SUBJECT: Triangle Expressway Southeast Extension (Complete 540) from NC 55 Bypass in Apex to US 64/264 (I-87) in Knightdale, Wake and Johnston Counties; Federal Aid No. STP-0540(19), STP-0540(20), and STP-0540(21); WBS Nos. 37673.1.TA1, 35516.1.TA1, and 35517.1.TA1; STIP Project Nos. R-2721, R-2828, and R-2829

Also, please reference your November 25, 2025 email, requesting modification of the permit to authorize change of impacts at Permit Sites 14, 15, and 31, for R-2829B. The modifications at 14 and 15 are necessary for an alternate Neuse River bridge design that reduces the overall length of the bridge by 290 feet, saves approximately \$2 million in construction costs, reduces bridge construction time by 23 weeks (including short term impacts to the river and the Neuse River Greenway), and reduces required concrete truck trips by 262 loads.

The Corps has completed the evaluation of your request and has determined that it is appropriate and reasonable, and that no public notice is required for this modification. Therefore, the permit is modified as requested and as shown on the enclosed R-2829B Mod Permit Drawings, Sheets 1, 30-39, 76, and 110-112, submitted November 25, 2025.

PERMIT DRAWING
SHEET 36 OF 112

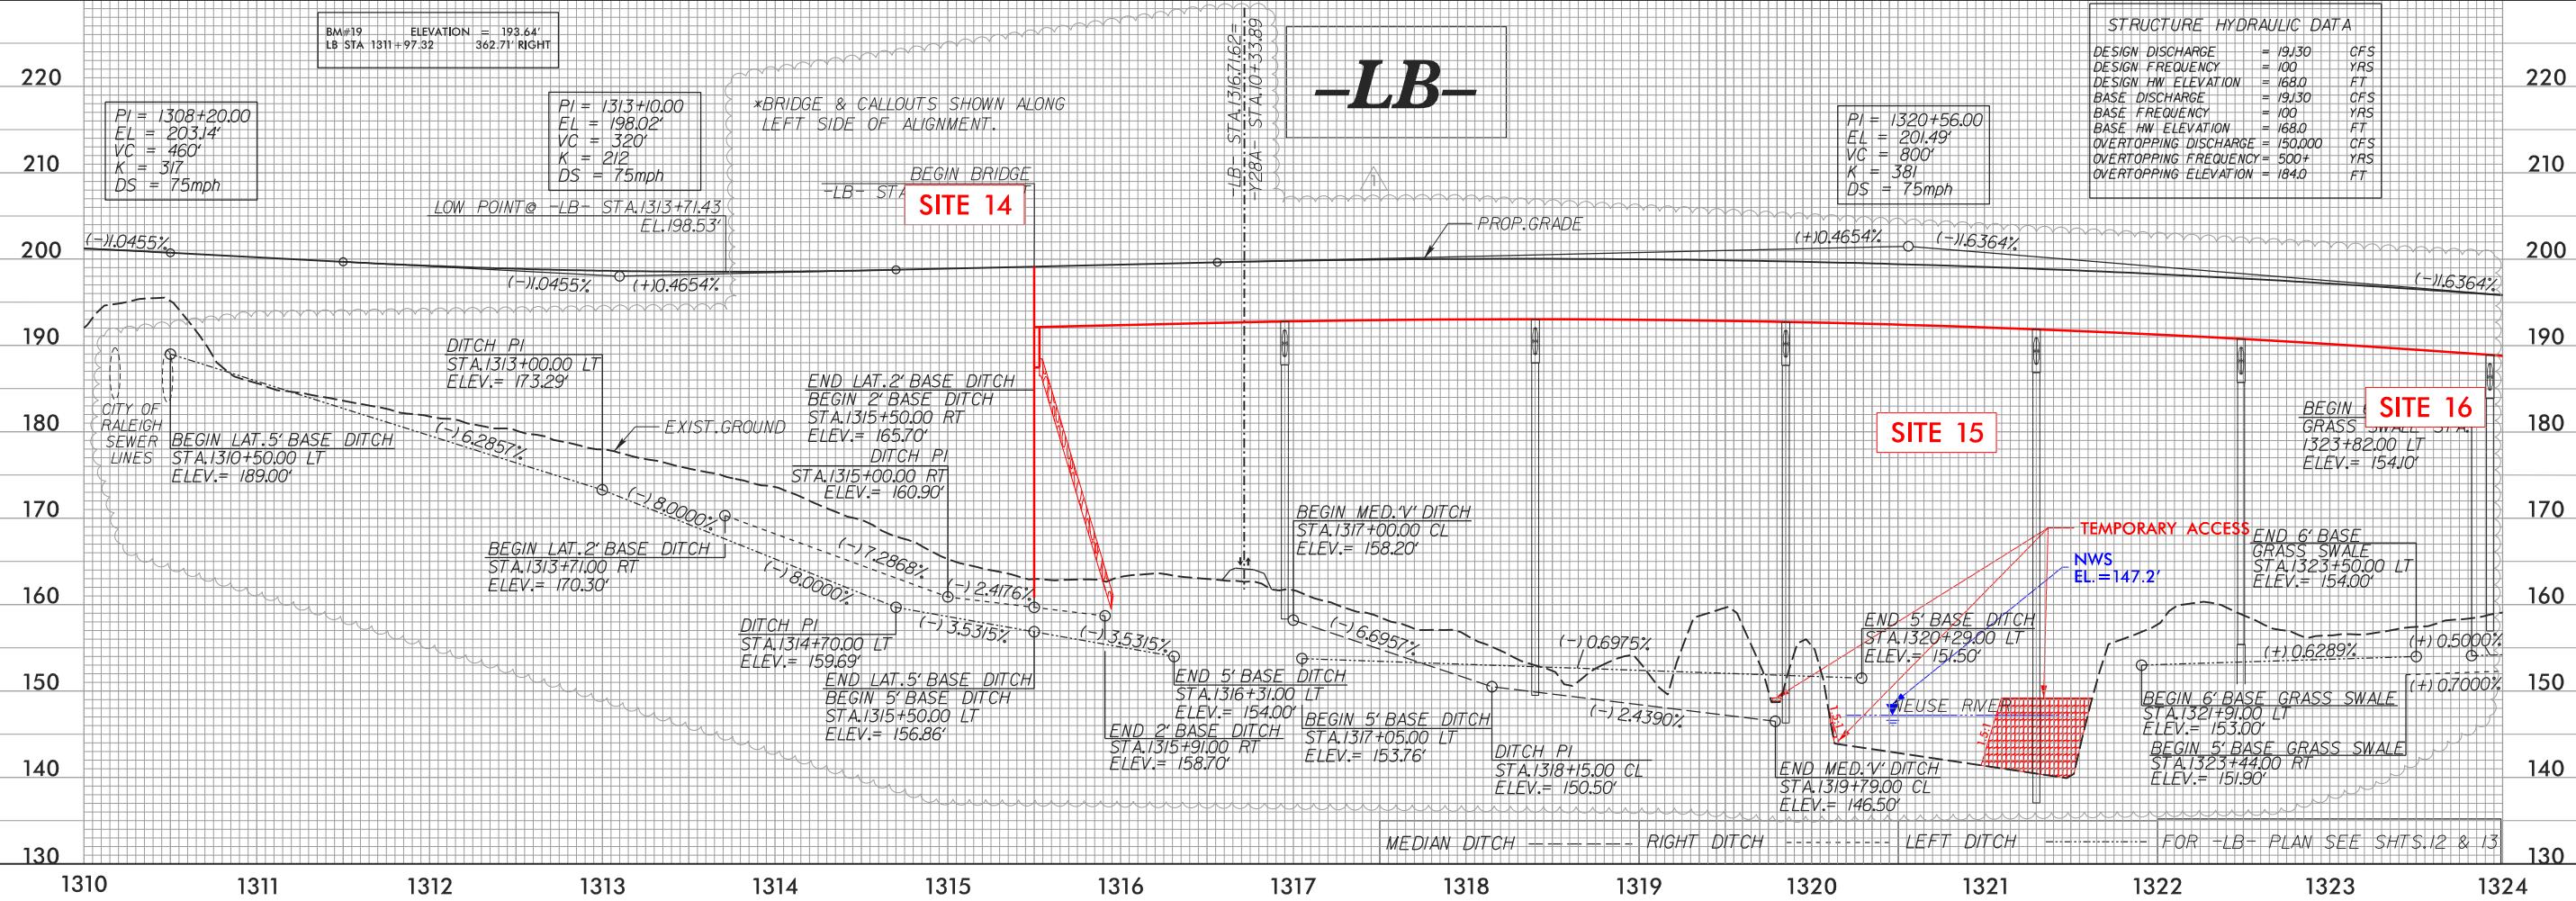
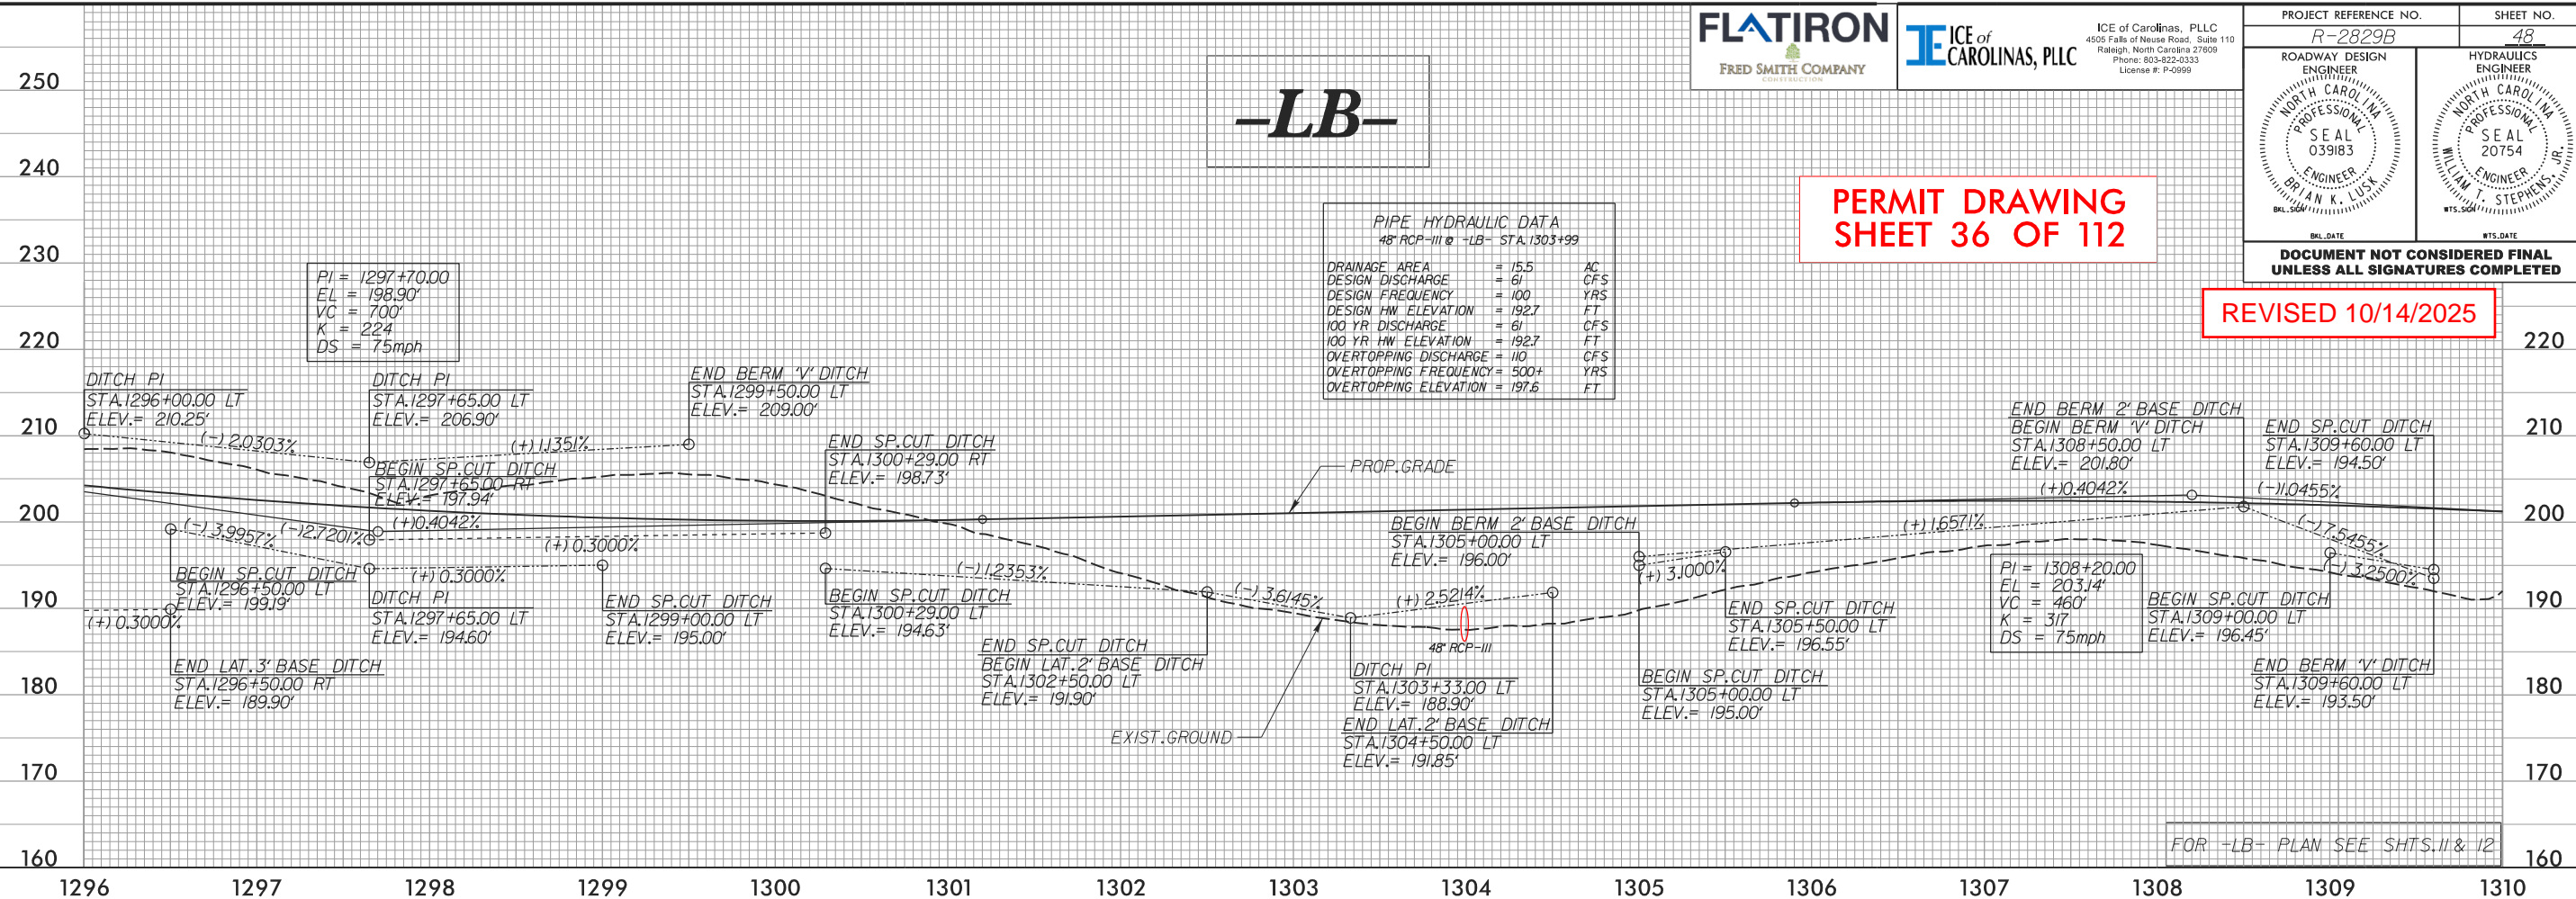
5/12/2025: UPDATED BRIDGE STATION CALLOUTS AND DITCH PROFILES FOR NEUSE RIVER BRIDGE REDUCTION.

PERMIT DRAWING
SHEET 38 OF 112
REVISED 10/14/2025

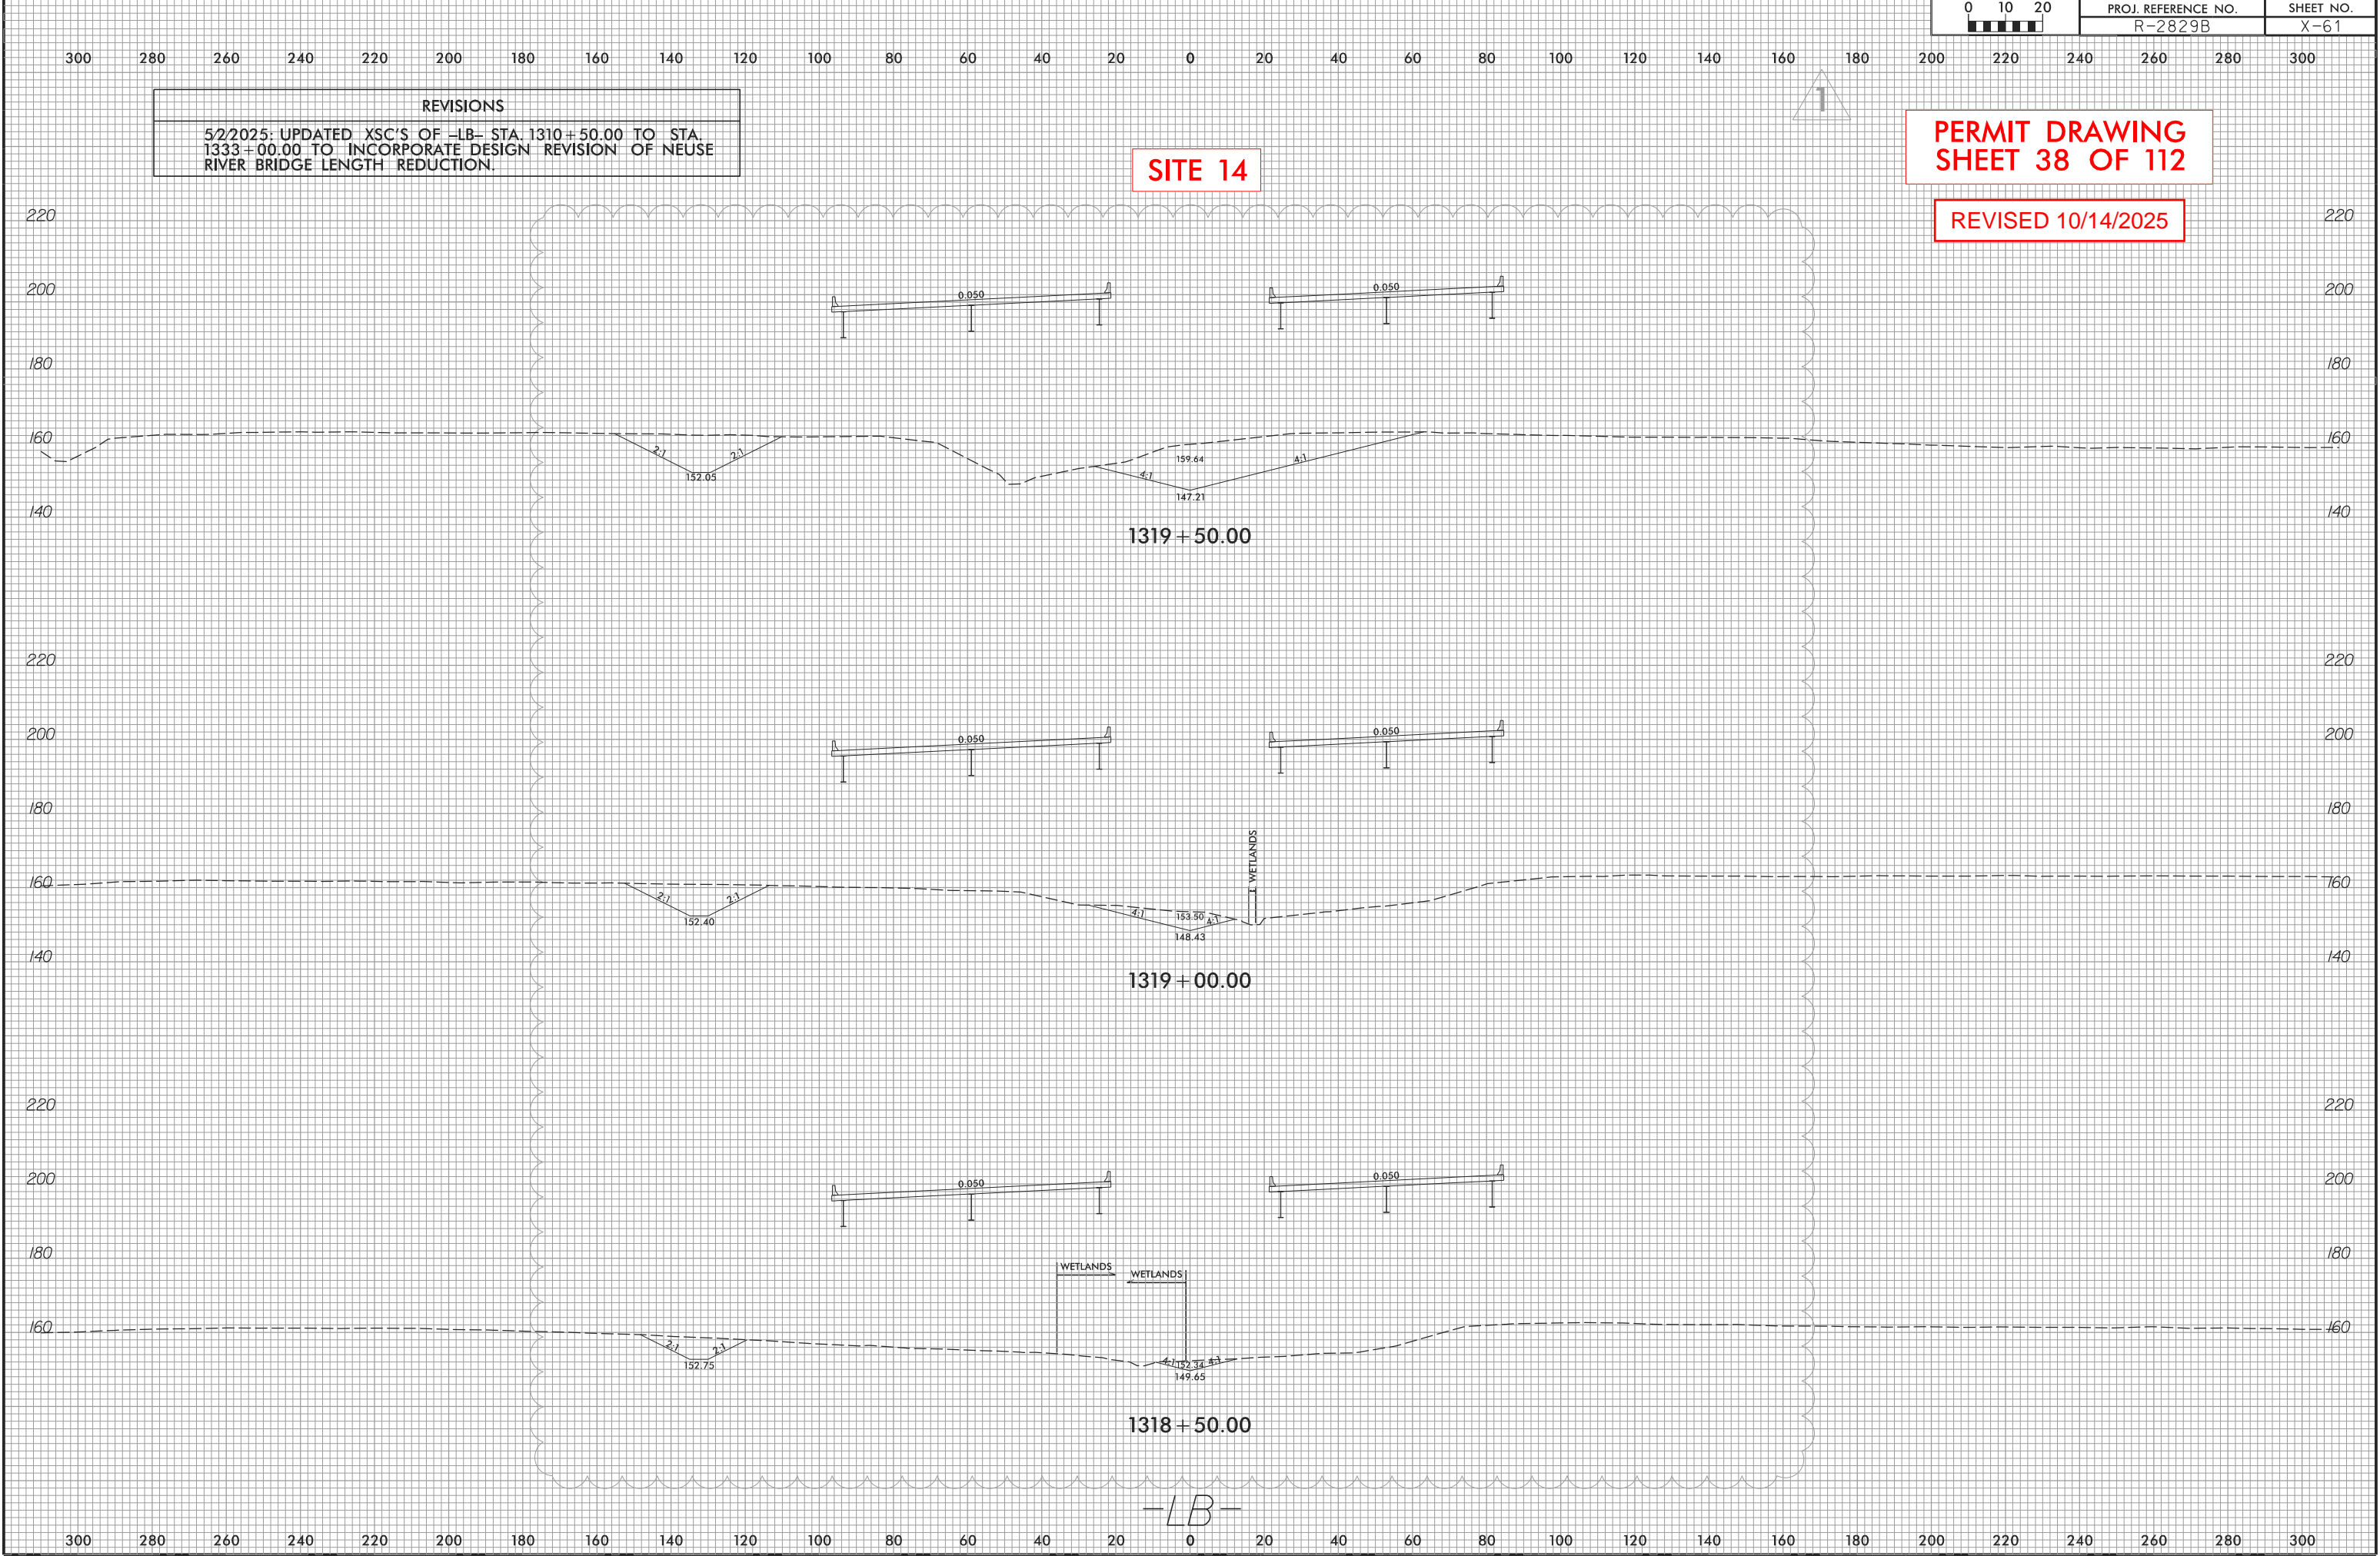
Site 14: Impacts from southern end bent relocation

- Fill in Wetland: 0.036 ac (previously 0 - increase of 0.036 ac)
- Excavation in Wetland: 0.021 ac (previously 0.002 - increase of 0.019 ac)
- Mechanized Clearing in Wetland: 0.030 ac (previously 0.011 - increase of 0.019 ac)
- Permanent Surface Water Impacts: 500 lf (previously 442 - increase of 58 lf)
